In the Matter of a Proposed)
Rulemaking to Amend Commission)
Rule 4 CSR 240-18.010.)

Errata to 2012 Edition National Electrical Safety Code®

Correction Sheet
Issued 29 April 2013

Figure 234-4(b)—Clearance envelope for grain bins filled by portable augers, conveyors, or elevators

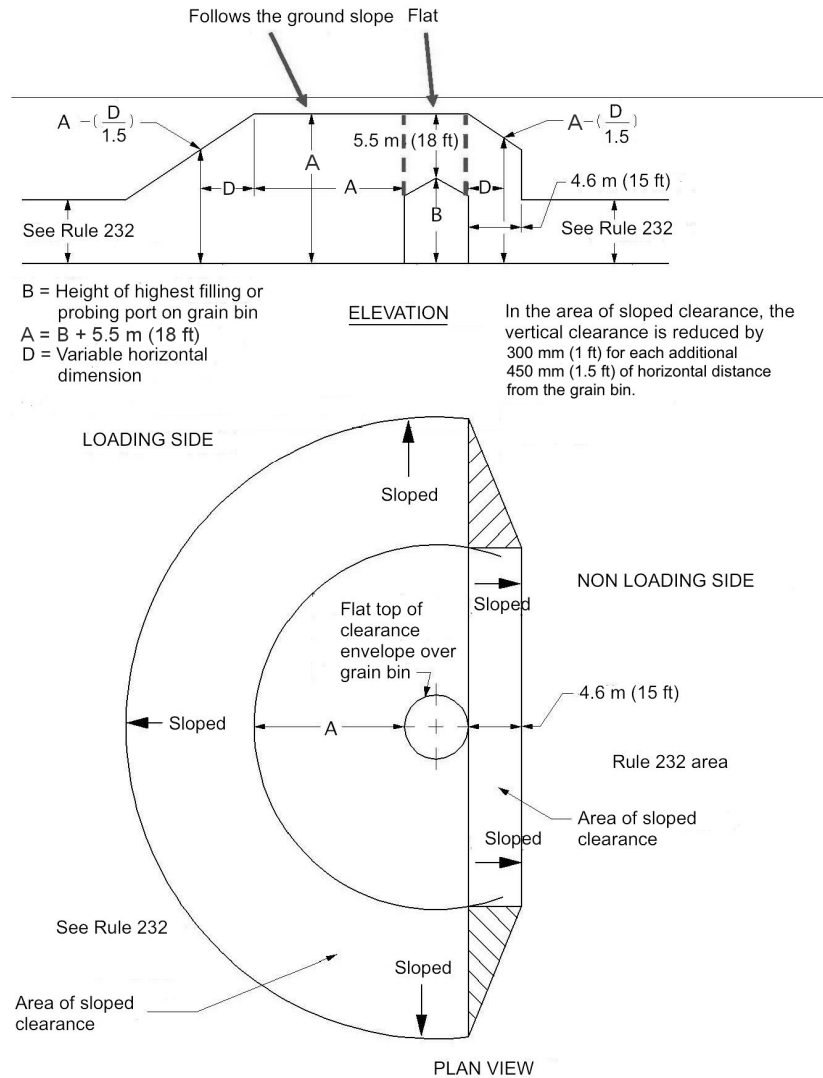
Page129: There are three errors in Figure 234-4(b). At the top of the figure, the two instances of “H” should read “A.” The text associated with “A” in the legend should read “B + 5.5 m (18 ft)” and not “V + 5.5 m (18 ft).”
